Item 1 BCAC Admin – draft in progress 6-5-2023 – ready to move to CAC’s.

BCAC Accessible

BCAC

1030.16.3 Mid-aisle termination. Mid-aisle *handrails* shall not extend beyond the lowest riser and shall terminate within 18 inches (381 mm), measured horizontally, from the lowest riser. *Handrail* extensions are not required.

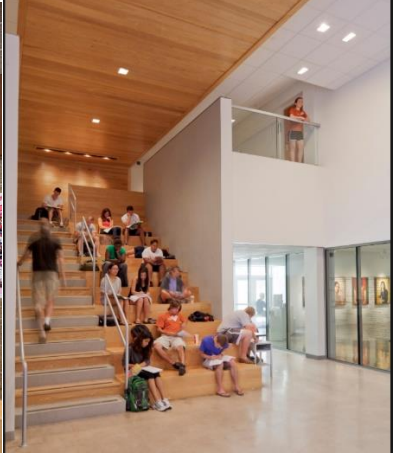
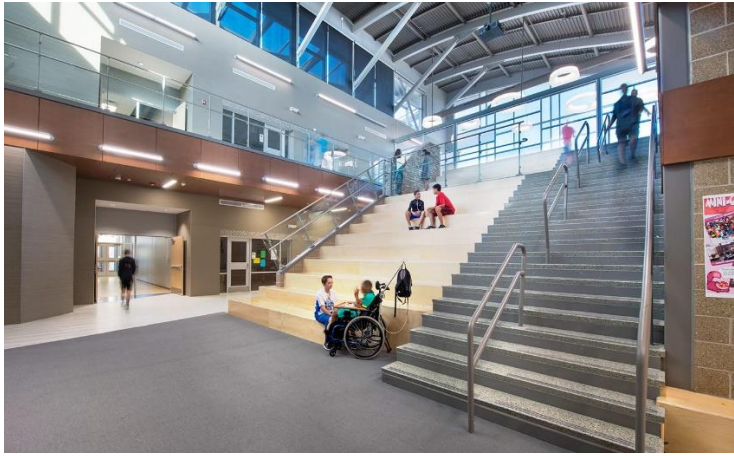
Reason: E106-18 added criteria to 1030.16 to address social stairways.

The question at this point is where there is this type assembly seating immediately adjacent to the egress from the upper floor – how should the capacity of the combined stairway/stepped aisle be calculated? We feel that the proposed language would clarify this issue.

Exception: Mid-aisle *handrails* shall be permitted to extend beyond the lowest riser where the *handrail* extensions do not obstruct the width of the cross *aisle*.
